Subject: Duke Energy Carolinas, LLC
Oconee Nuclear Station, Units 1, 2 and 3
Renewed Facility Operating Licenses Numbers DPR-38, 47 and 55;
Docket Number 50-269, 50-270 and 50-287;
Supplement to License Amendment Request for Measurement Uncertainty
Recapture Power Uprate,
License Amendment Request No. 2011-02, Supplement 2

Response to NRC Request for Additional Information

Attachment 1
Sketch 1

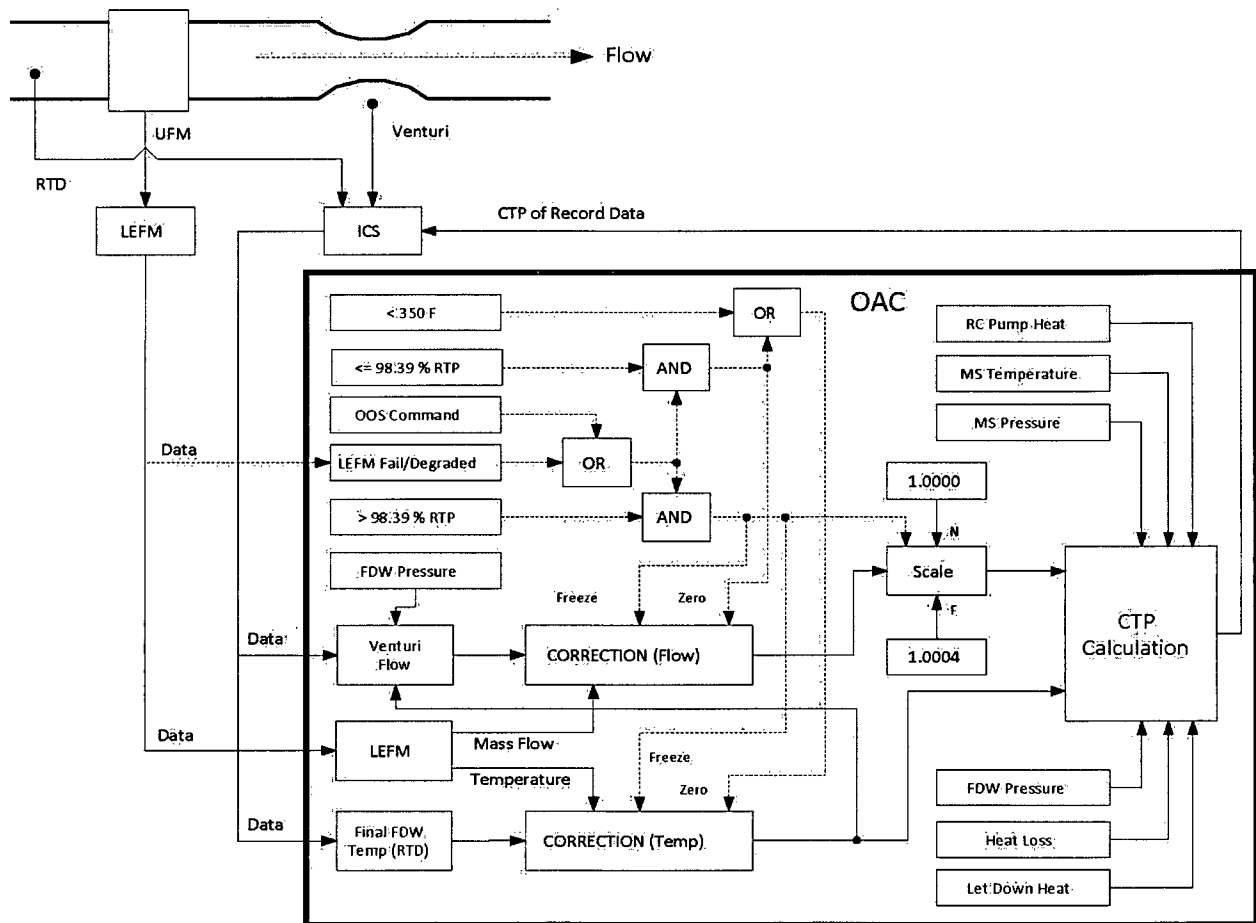
Enclosure 2, Item I.1, requires the licensee to provide a description of the plant-specific implementation of the feedwater flow measurement technique. The information provided in the LAR does not describe the arrangement, the instrumentation in the complete system that would acquire the flow data and calculate the power level, or whether the LEFM would provide data to

the plant process computer system for use in the calorimetric power algorithm. Also, describe how the data from the LEFM will be used (or not) if the plant computer fails. Provide a diagram that depicts functionally the instrumentation used to perform the secondary calorimetric; using either the feedwater flow venturi or the LEFM CheckPlus system.

The ICS is shown only to indicate the particular inputs of Feedwater Flow and Temperature, and feedback of CTP from the OAC, out of several hundred ICS related data points fed to the OAC. The LEFM CheckPlus does not feed any signals directly to the ICS. The ICS response to LEFM CheckPlus failures occurs only as response to CTP information from the OAC.

The interactions between signals provided by the ICS and LEFM are done within the OAC. The OAC uses the ICS signals primarily for internal calculations, but uses the LEFM to correct the ICS provided readings for accuracy. The ICS data is used as the primary input to CTP calculations because its update period is one second, whereas the LEFM update is every 5 seconds. The ICS data is therefore timelier for analysis.

Attachment 2
O-800, Oconee Nuclear Station One Line Diagram Relays & Meters 230 kV Switchyard PCB's 1 - 12

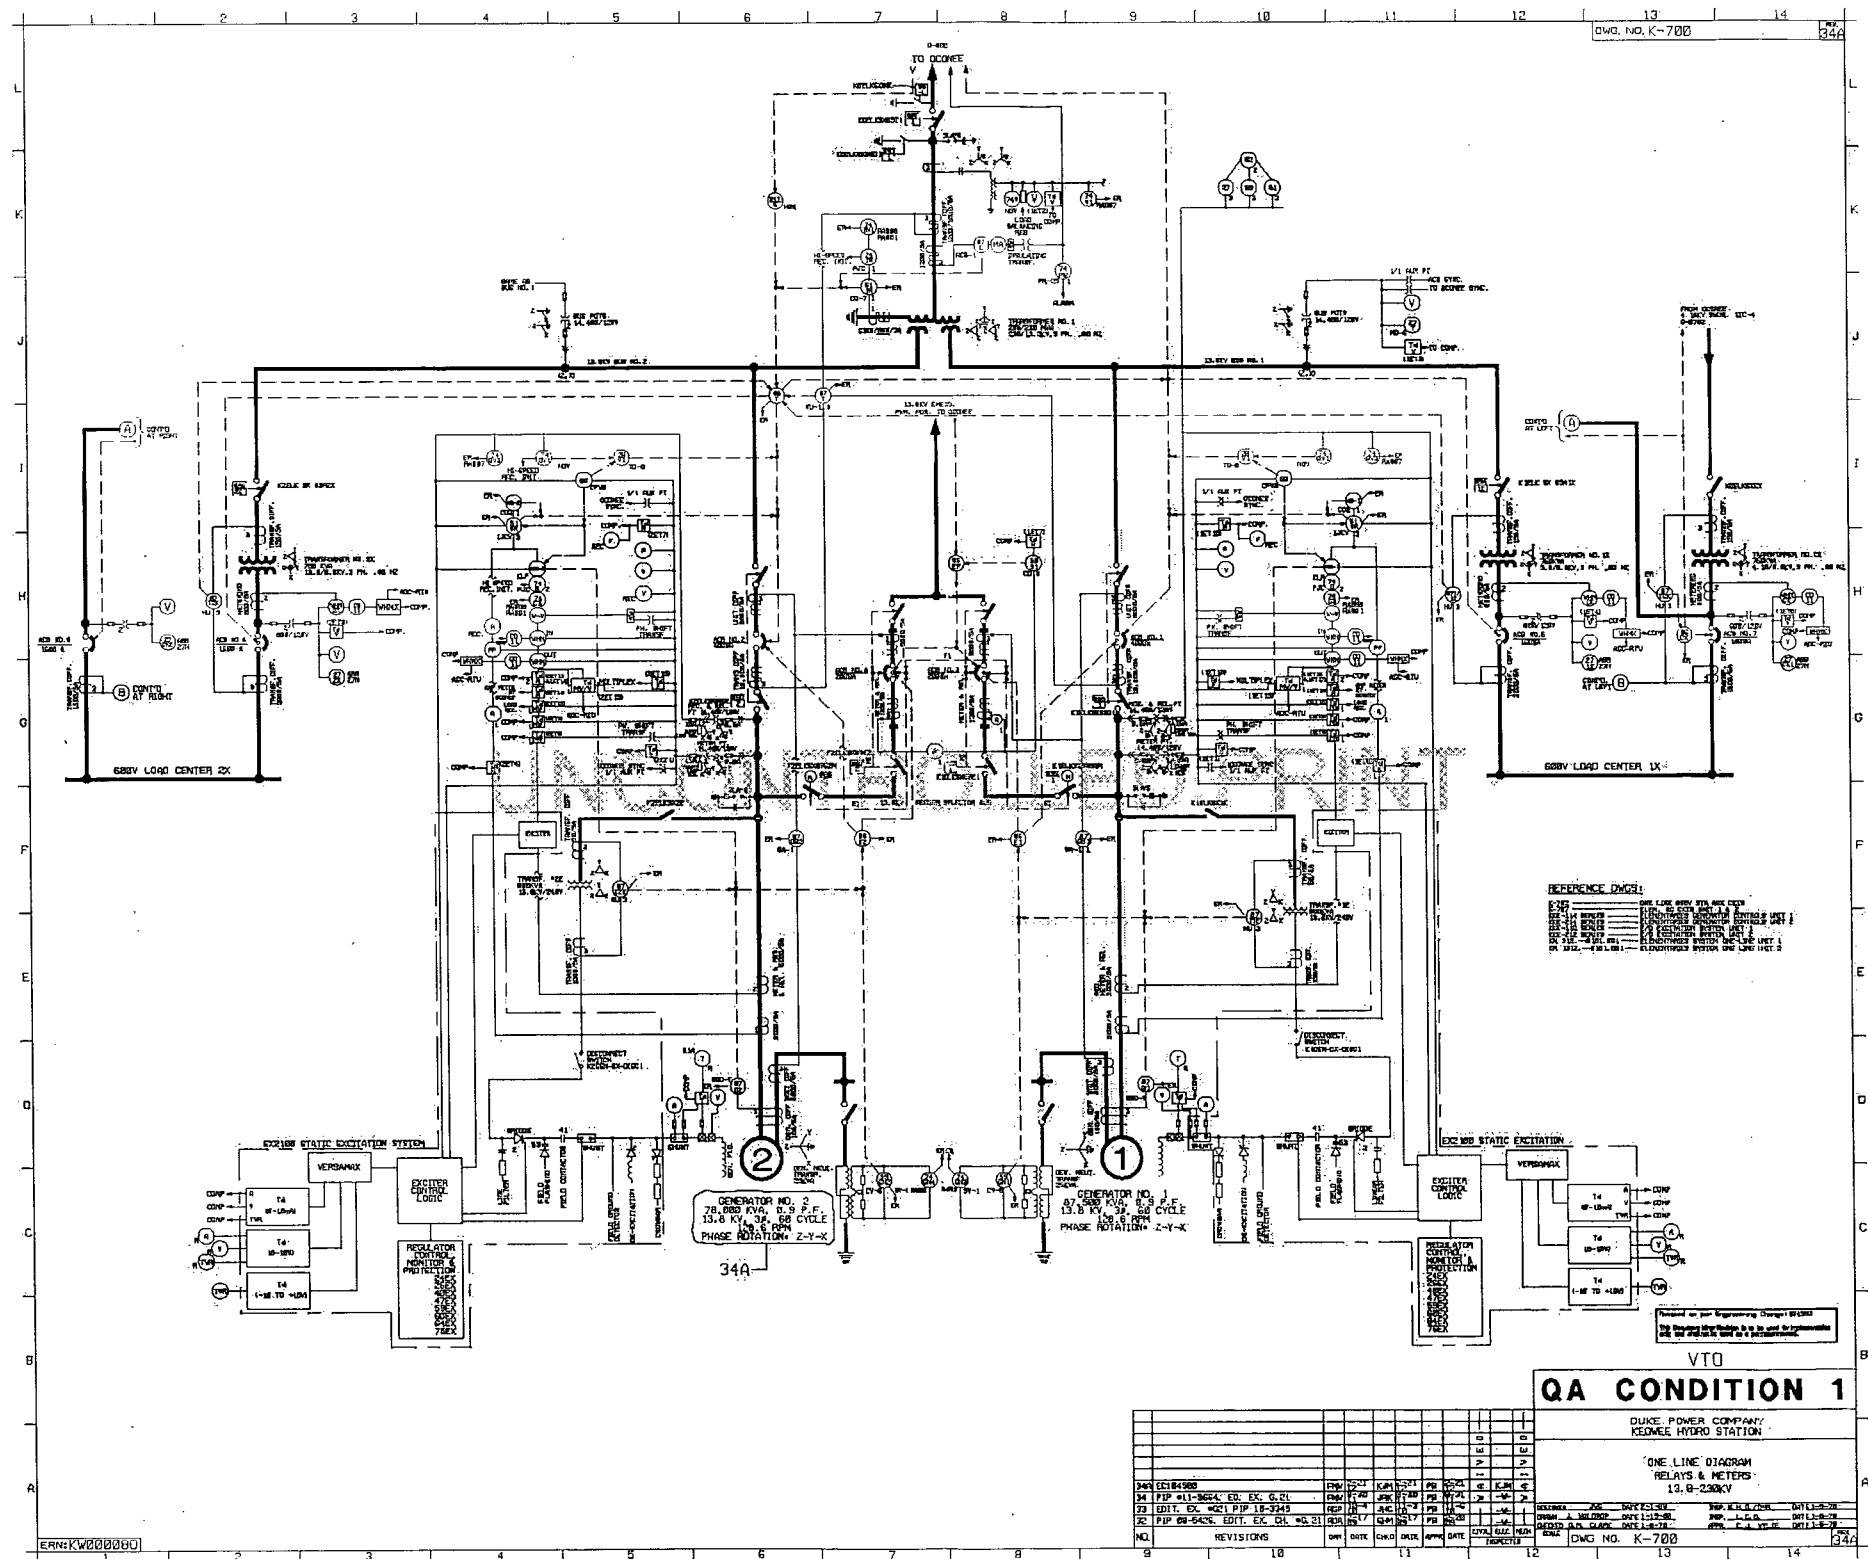
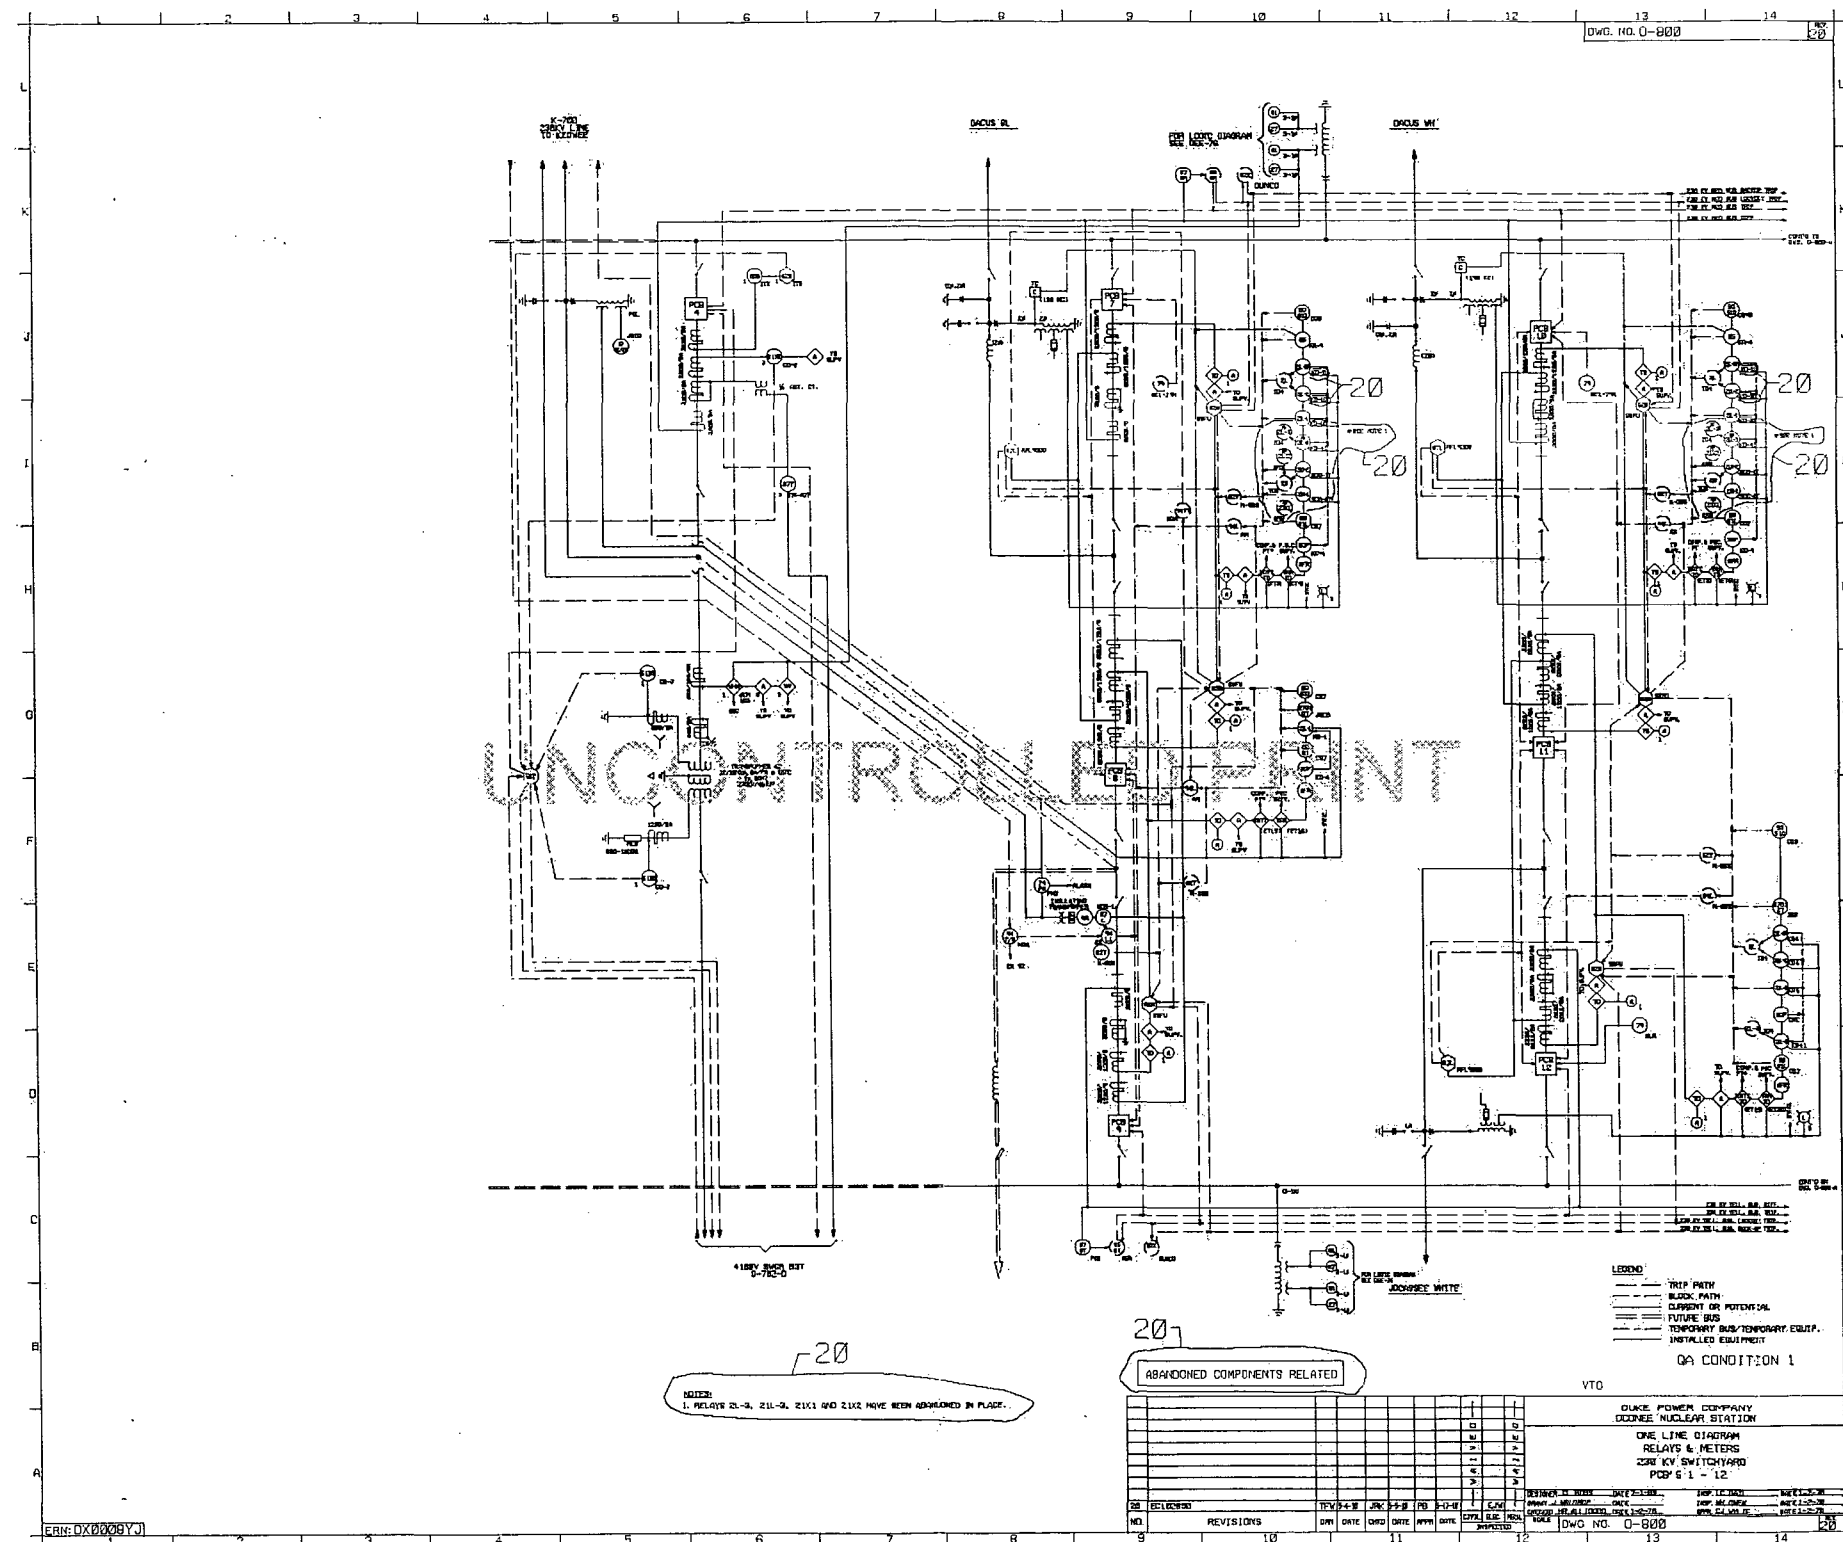
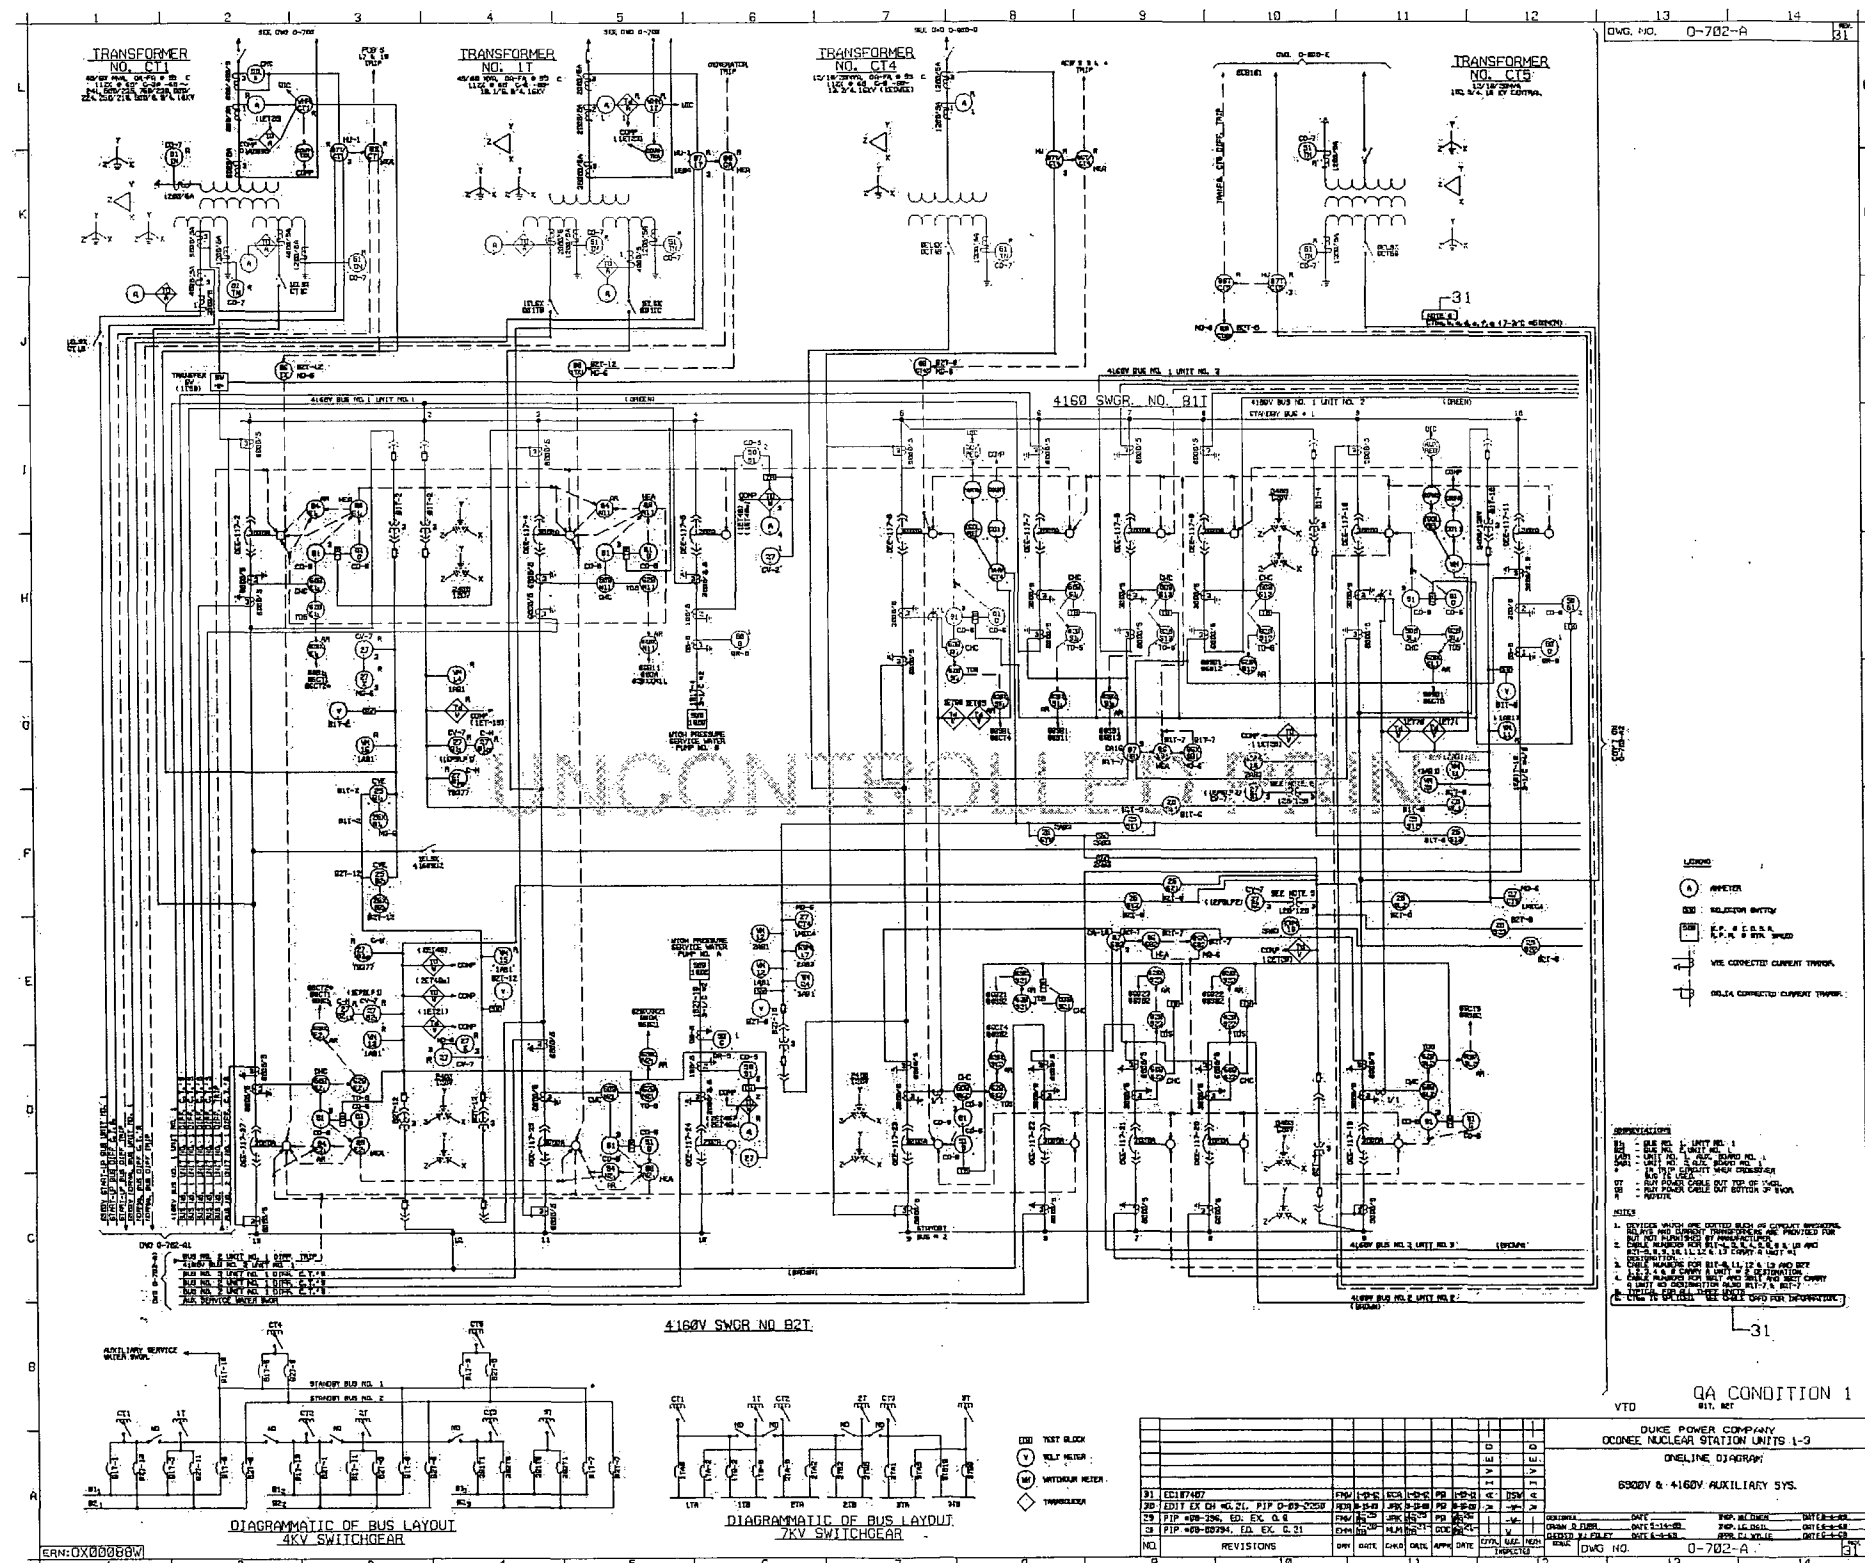
Provide a current main single line diagram that identifies and shows the interconnection of the equipment described in this section. Provide a summary of the evaluation that supports your conclusion that plant operation under MUR power uprate conditions are bounded by the loading tables as indicated in Section V.1.A of the LAR.

A summary of the evaluation that supports the conclusion that plant operation under MUR power uprate conditions are bounded by the loading tables is provided as follows. The current ETAP model is already conservative enough to exceed loading increases required for achieving the MUR power uprate. For this reason, there is no change to the AC Distribution Systems for the MUR power uprate. Therefore, the rating of the Keowee Hydro Units will not be exceeded.
